# Staff Report

**Meeting Date:** November 10, 2022 (Prepared November 3, 2022)

**Item:** “Mill Creek Meadows” Planned Unit Development (PUD 22-01)

**Tax Lot(s):** 051W18C000600 [primary] & 800 and 051W19B000200 (1490, 1550, & 1636 Brown St)

Site plan (Sheet 2/6); this draft submitted September 29, 2022 correctly shows the Aspen Street south stub

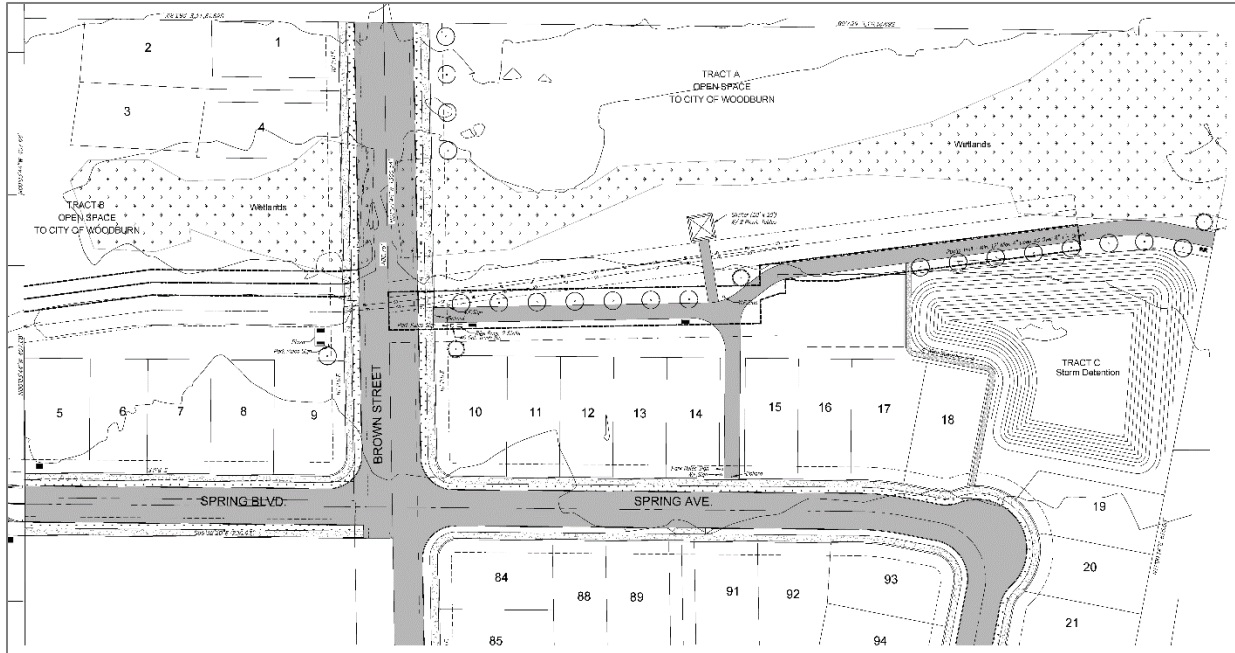
Staff adds regarding criterion B.1 that it is the basis for a condition requiring a south stub of Aspen Street to adjoin 875 S. Pacific Hwy (Tax Lot 051W19A002000). This adds to the 3 street stubs that staff had requested and the developer proposes for each of Brown Street, Upland Avenue, and E. Traverse Road (the "South Arterial" from the Transportation System Plan, Table 2, p. 33, Project R29 and with conceptual alignment mapped in TSP Figures 2 & 3). The subject property east boundary would have two stubs and the south boundary two stubs. Specifically, Mill Creek diagonally crosses 875 S. Pacific Hwy NE/SW and leaves a NW corner of the property bound by the creek and north and west lot lines. The Aspen Street stub adjoins this area and allows for its development in the indefinite future without a street crossing the creek.

- (3) Planter strips and sidewalks: Per condition parts f(3) & (4) below.
  - (4) Aspen: The developer shall extend Aspen ROW and its improvements from Vail to the easterly south line of the subject property, with specific requirements of min width 46 ft of ROW, min pavement width between faces of curb of 20 ft, and planter strips and sidewalks min widths per condition parts f(3) & (4) below.

Figure 3.01C – Minor Arterial (This applies to E. Traverse Road.)

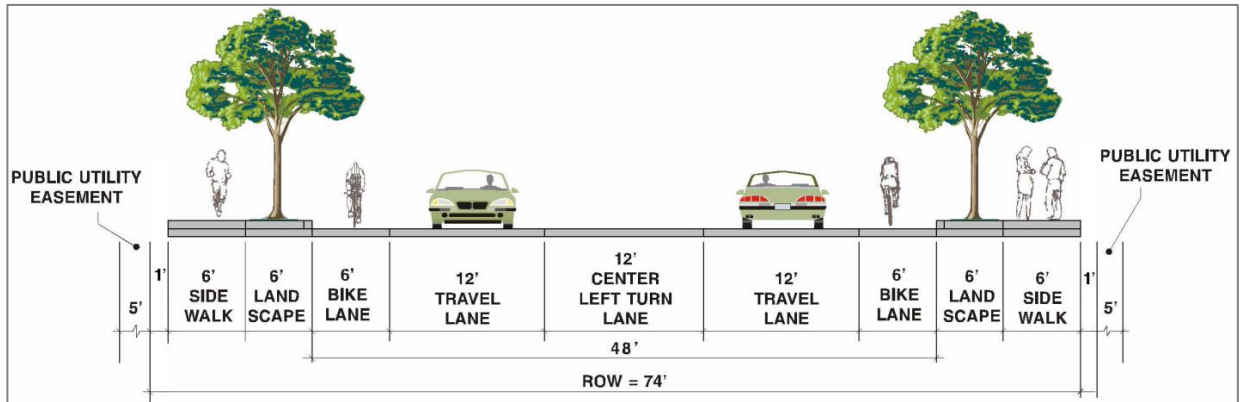
- a. Applicable cross section: The TSP contains a conflict in that the text listing of R29 specifies the South Arterial as a two-lane road, while Figure 2 indicates that it is Major Arterial class for which the WDO standard cross section is a four-lane highway per Figure 3.01B.

For pre-application meeting PRE 21-25 on September 8, 2021, agenda p. 3, Item A4 identified the conflict and indicated that staff resolved the conflict (in favor of the literal text over the conceptual figure) and that the developer and future developers of the rest of the planned road should proceed accordingly per Figure 3.01C “Minor Arterial” class.

- a. Traverse: Based on TSP Project R29 "South Arterial" (TSP p. 33), per WDO Fig. 3.01C, modified as follows and by condition parts farther below including f(3) & (4) regarding planter strips and sidewalks. Median:

Figure 3.01G – Local Residential Street with Parking Both Sides, 60 Foot Right-of-Way (This applies to remaining streets.)

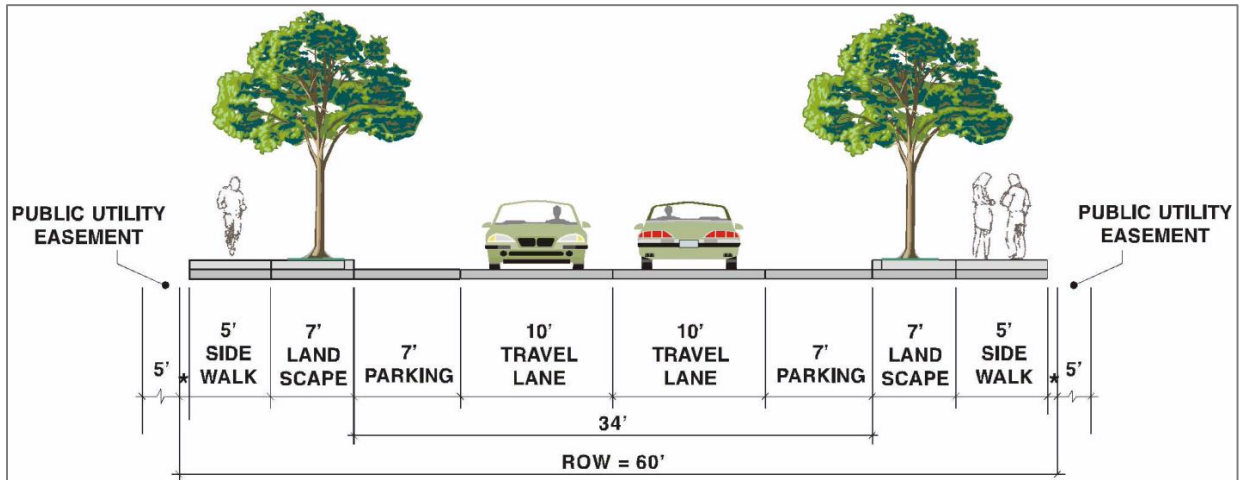
The proposal includes modification by PUD of the standard local street cross section from the 60-foot one of Figure 3.01G to a 50-foot custom one. The site plan sheets of street cross sections lack a local street one. A PUD condition specifies the cross section standards for local class streets that will be the premise for the developer and the Public Works Department Engineering Division during civil engineering plan review (CEP). Landscape strips (with street trees) and sidewalks remain required.

- (4) Planter strips and sidewalks: Per condition parts f(3) & (4) below.
- c. Local class streets: Based on WDO Fig. 3.01G as modified by Condition PUD-3f below and as follows:
